From: [Chris Beale](#)
To: [Dougherty, Logan \(Consultant\)](#)
Cc: [Erickson, Vivian \(Consultant\)](#)
Subject: (EXTERNAL) RE: SR 167 St 2 - SSDP - Geotech
Date: Thursday, February 23, 2023 8:41:55 AM
Attachments: [image001.png](#)
[image002.png](#)
[image003.png](#)
[image004.png](#)

From: Dougherty, Logan (Consultant) <DoughLo@consultant.wsdot.wa.gov>
Sent: Thursday, February 16, 2023 1:53 PM
To: Chris Beale <CBeale@PuyallupWA.gov>
Cc: Erickson, Vivian (Consultant) <ErickVi@consultant.wsdot.wa.gov>
Subject: SR 167 St 2 - SSDP - Geotech

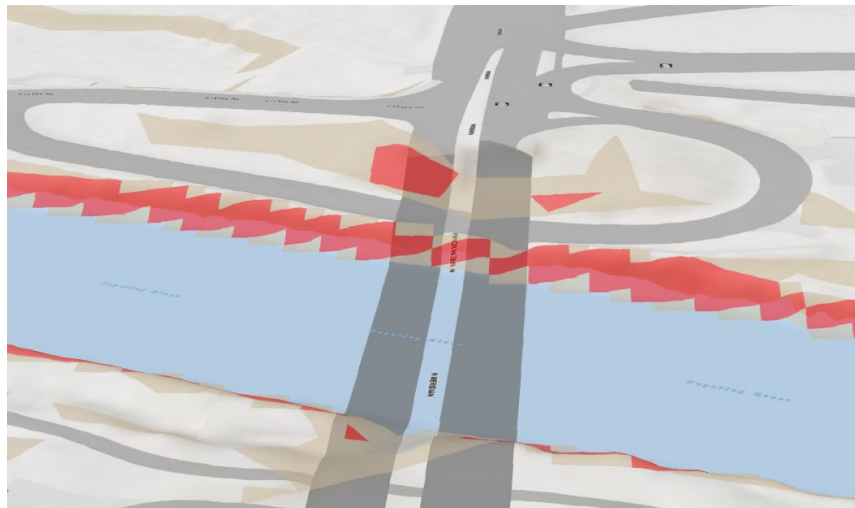
Thanks so much for your time this morning. As requested, we've provided a general description of existing conditions in the shoreline jurisdiction area and an explanation of the required future geotechnical documentation from the Design Builder, as a geotechnical report will not be included in WSDOT's SSDP application. Please let us know if the description and images below provide enough context for you to follow up with your division manager.

WSDOT's SSDP application will not include a geotechnical report, as requested in the pre-application meeting notes, however, the Design-Builder will be required to provide a final Geotechnical Documentation Package and final design consistent with WSDOT's Geotechnical Design Manual, which includes provisions for development associated with steep slopes. While there are mapped steep slopes within the shoreline jurisdiction, these areas appear to be within existing disturbed areas associated with roadway prism, levee embankments, and rip-rap revetments (see snippets below). All roadway improvements are proposed landward of the existing North Levee Road. The only work proposed waterward of North Levee Road is the replacement of the existing guardrail and an existing stormwater outfall, which has reached the end of its useful life and its replacement is therefore required per WSDOT policy. The outfall will be replaced in-kind, including necessary revetment portions surrounding the outfall, as there is not a realistic way to replace the existing pipe without removing and replacing (in kind) riprap that forms the face of the revetment.

I spoke with our Division Manager and it is acceptable to defer geotechnical reporting to the final permitting stage given the context of this situation as you describe below. Please include this email correspondence in your submittal package to ensure there is documentation on this item.
